Sundry Print Report
07/23/2024

Well Name: BALLYMALOE Well Location: T23N / R7W / SEC 25 /

Notice of Intent

Type of Action: Plug and Abandonment

Planned P & A Schematic

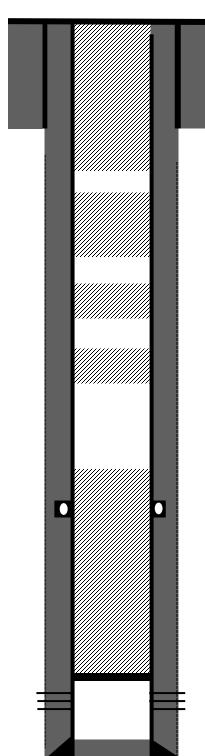
- 1. Plugging operations authorized are subject to the attached "General Requirements for Permanent Abandonment of Wells on Federal and Indian Lease."
- 2. The following modifications to your plugging program are to be made:
 - a. Modify Plug III, or add a plug, to account for the BLM formation top pick for the Chacra at 2870'.
 - b. For Plug IV, adjust the bottom of cement to 2120' to cover the BLM formation top pick for the Picture Cliffs at 2070'.
- 3. Farmington Office is to be notified at least 24 hours before the plugging operations commence at (505) 564-7750.

Comments: Please add cement to plug #3 down to 2,920' to cover the top of the Chacra formation and the first fifty feet.

Please add cement to Plug #4, down to 2120' to cover the top of the Pic. Cliffs and first fifty feet of the formation.
